**METROPOLITAN GOVERNMENT OF NASHVILLE AND DAVIDSON COUNTY**

**STAFF RECOMMENDATION**  
**1400 Ordway Place**  
**November 15, 2017**

**Application:** New construction—infill; Setback determination  
**District:** Lockeland Springs-East End Neighborhood Conservation Zoning Overlay  
**Council District:** 06  
**Map and Parcel Number:** 08309049000  
**Applicant:** Duane Cuthbertson  
**Project Lead:** Melissa Baldock, melissa.baldock@nashville.gov

**Description of Project:** Application is to construct two-story infill on a vacant lot. The infill requires a side setback determination from ten feet (10') to six feet (6') on the North 14<sup>th</sup> Street property line.

Figure 9. The existing curb cut on N. 14<sup>th</sup> St. will remain.

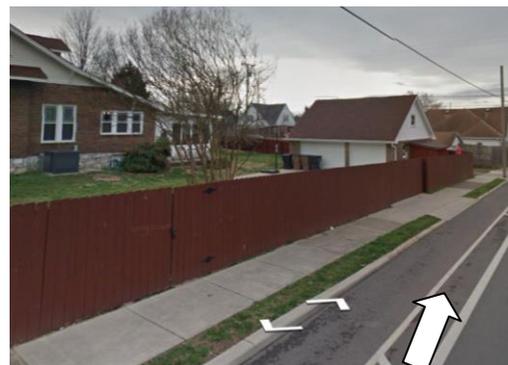
Orientation: The infill is oriented to face Ordway Place, which is appropriate. There is one primary entry behind a seven foot, four inch (7'4") deep, partial width front porch. Vehicular access will be via the alley and via an existing curb cut off of North 14<sup>th</sup> Street (Figure 9). Staff finds that the proposed infill meets Section II.B.6. of the design guidelines.

Figure 11 shows the fenestration issues on the left façade.

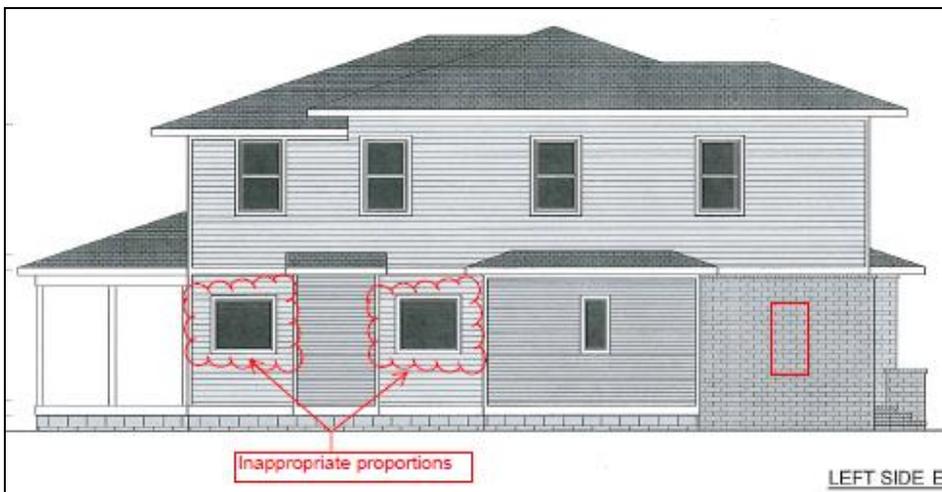
On the right elevation, there should be a window opening on the brick portion, first level, near the front of the house. In addition, the picture windows towards the back of the house are not twice as tall as they are wide, and therefore do not meet the historic proportion of window openings. See Figure 11 for illustration.
